**APPENDIX 6**  
**GROUNDWATER MONITORING PLAN**

Re: ADEM Letter of January 20, 2021  
Response to Groundwater Monitoring Plans Submitted to the Department  
William C. Gorgas Electric Generating Plant

The following provides responses to comments received in a letter from the Alabama Department of Environmental Management (ADEM) Land Division dated January 20, 2021. The letter pertains to the revised groundwater monitoring plans (GWMPs) submitted to the Department on August 24, 2020, for the (1) Ash Pond, (2) Bottom Ash Landfill, (3) CCR and Gypsum Landfill, and (4) Gypsum Pond at the Alabama Power Company (APC) William C. Gorgas Electric Generating Plant. The following presents the full text of the comments provided by ADEM in italics followed by our response indented in plain text.

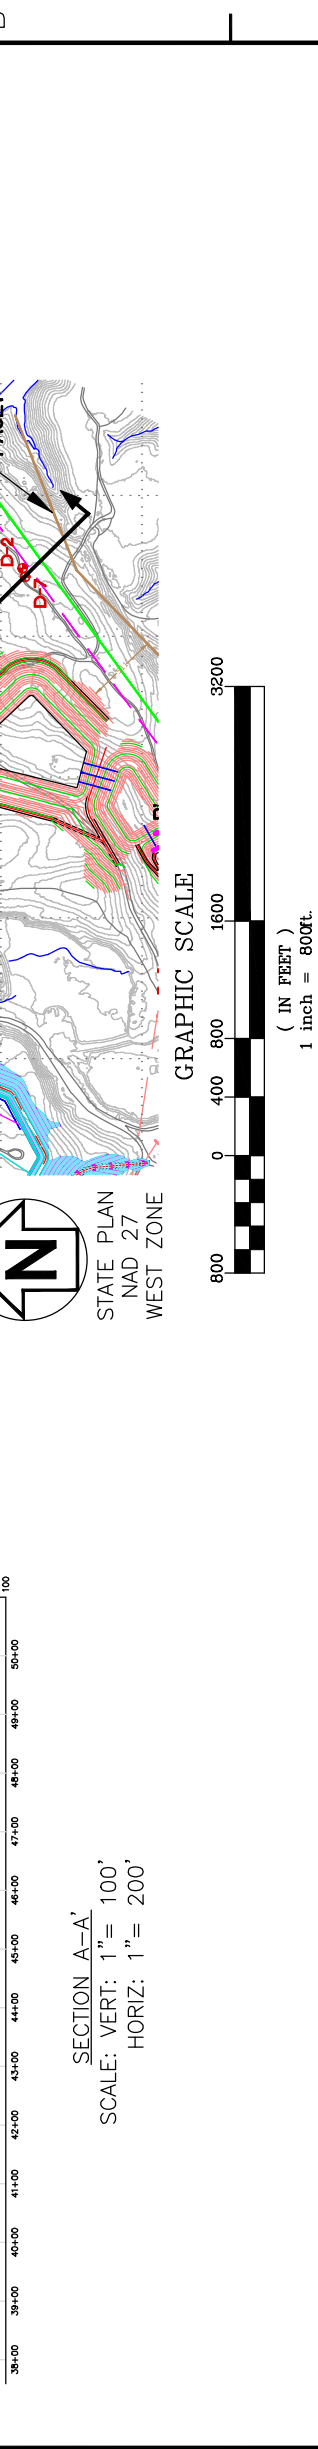
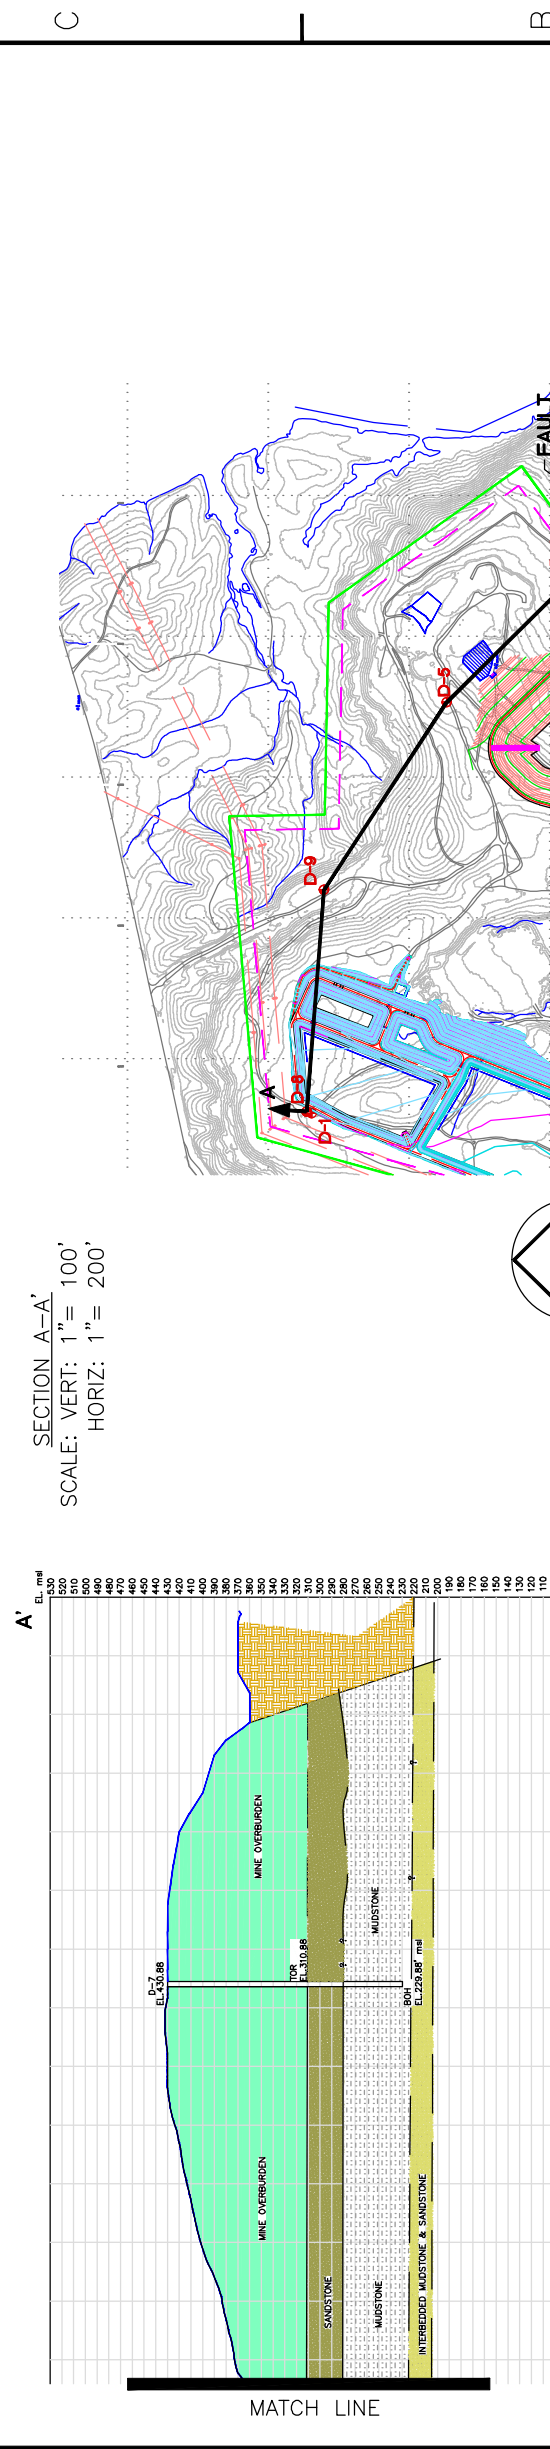
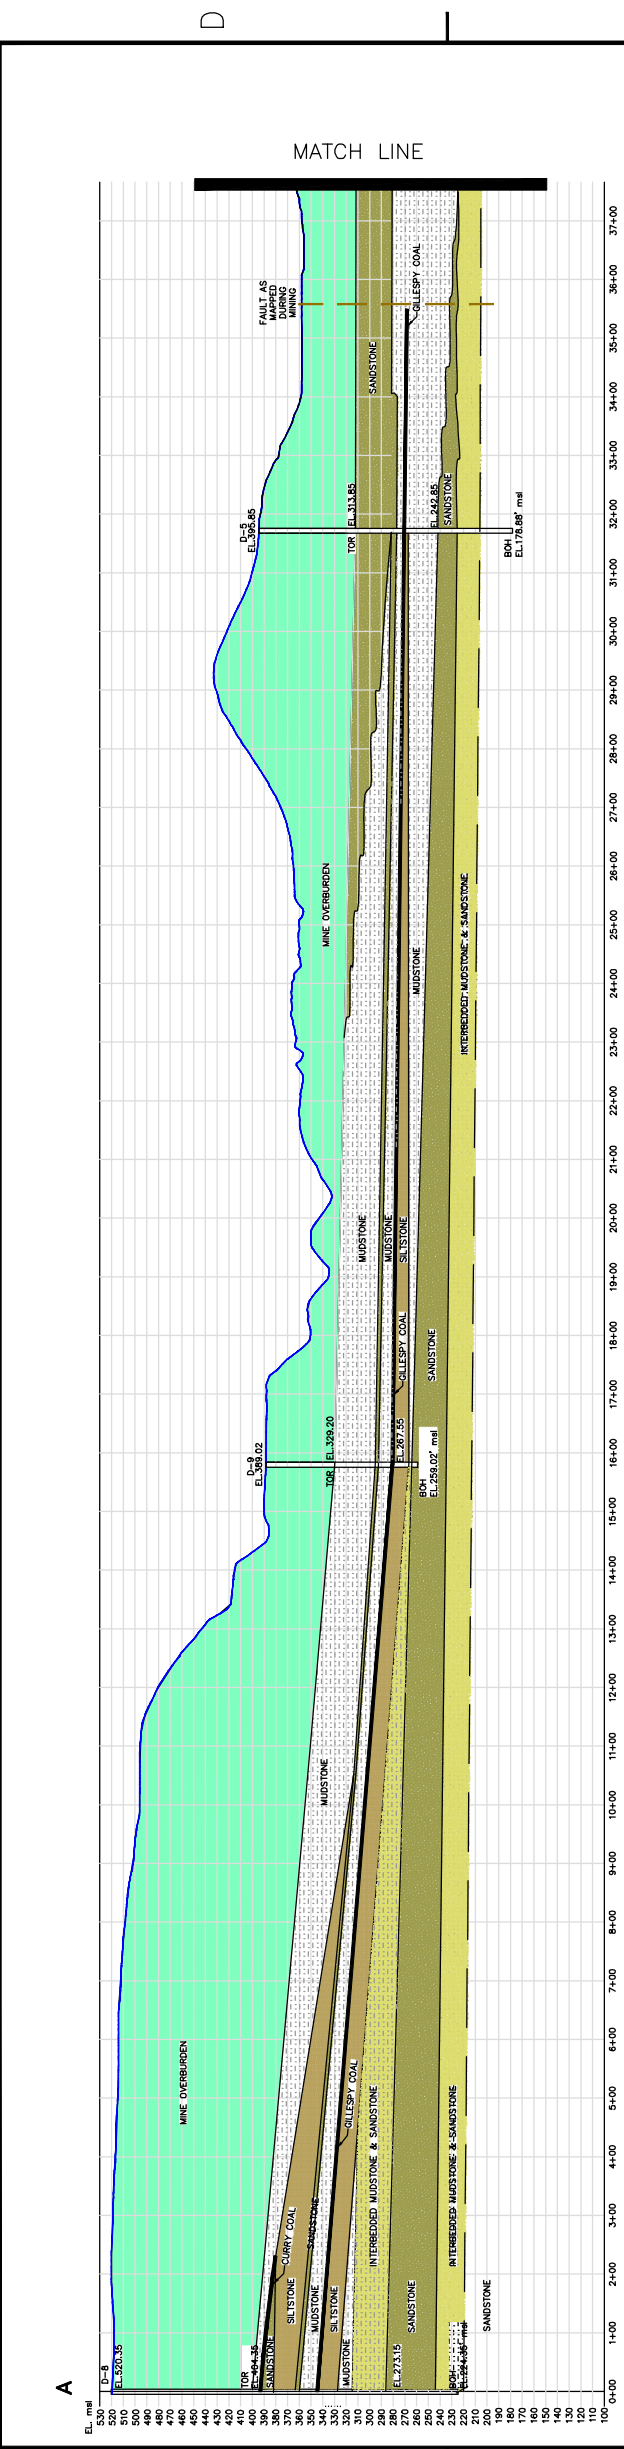
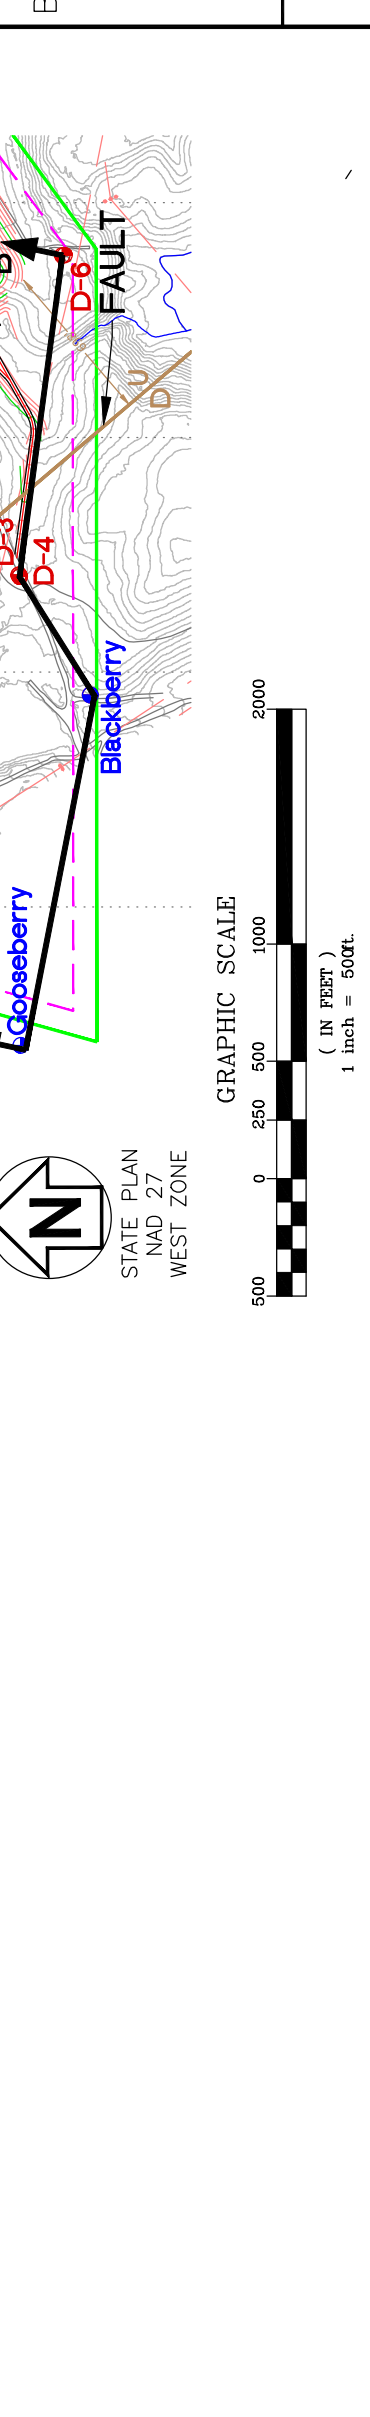
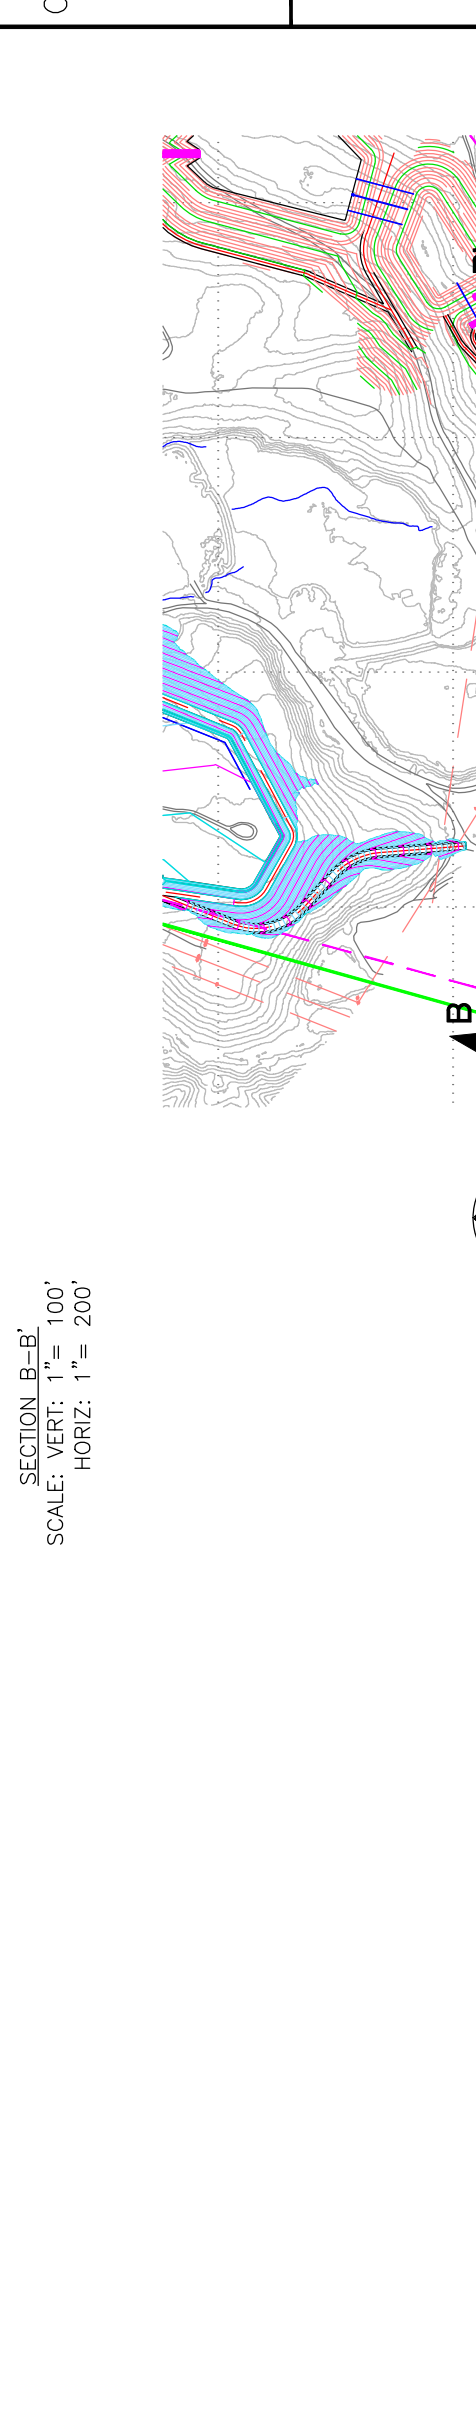
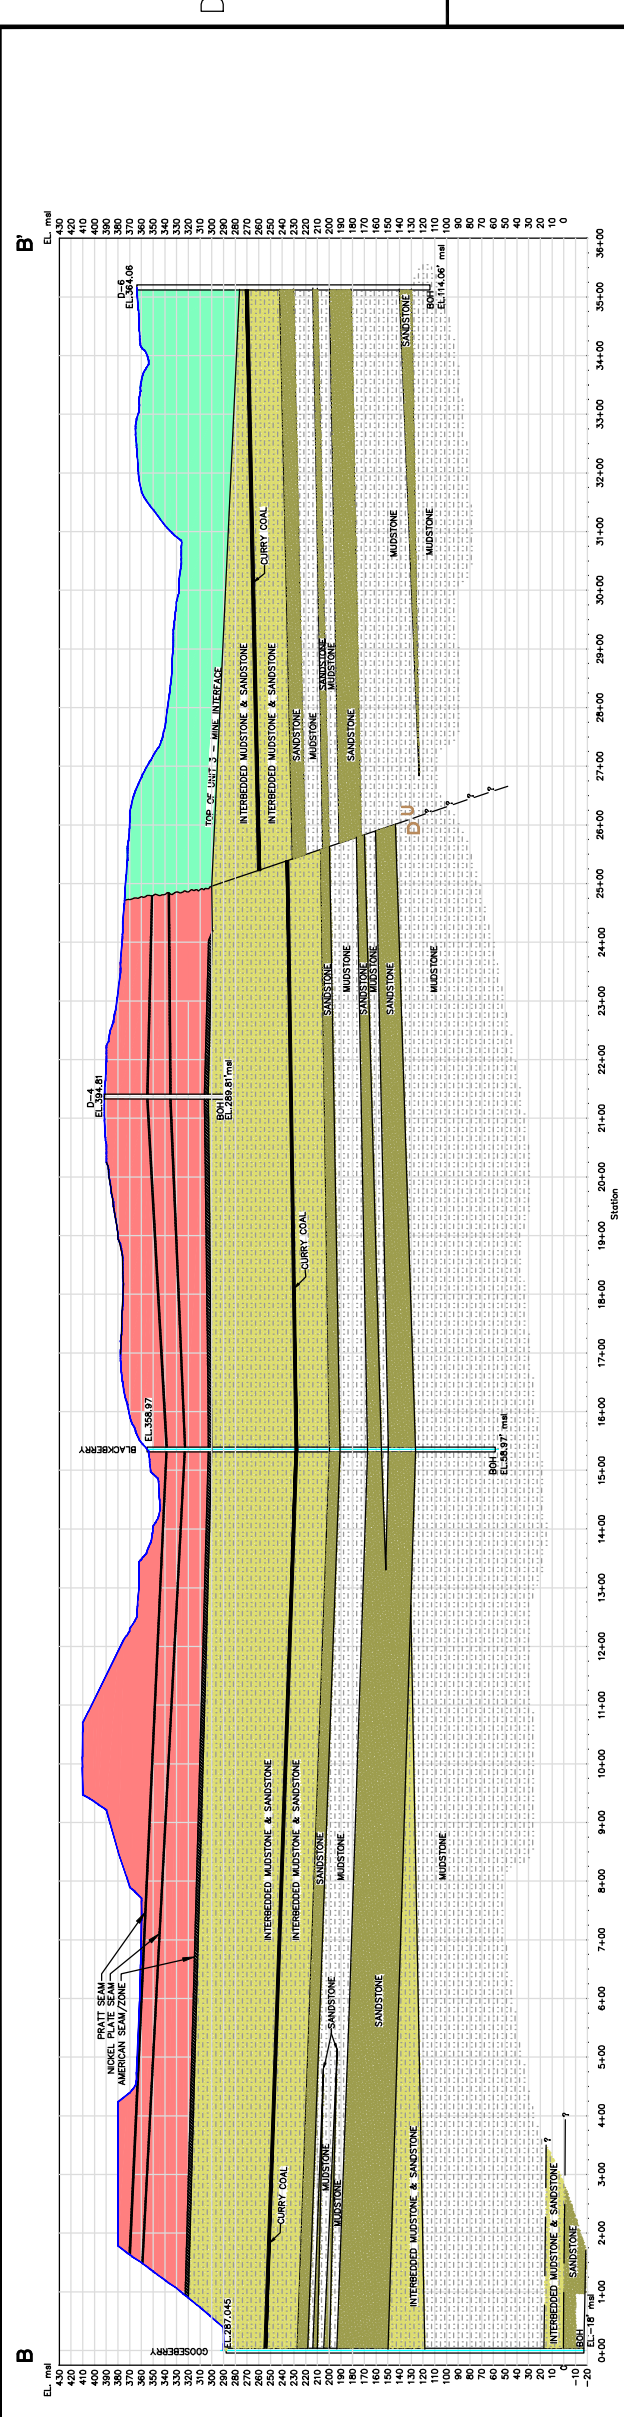
- 6. The faults depicted on figures 5A and 5b should be indicated on Figure 4.*

A revised figure including the faults is included in the attached *Supplemental Site Hydrogeologic Characterization Report*. Fault locations are included on Figures 3a and 3b of this report.
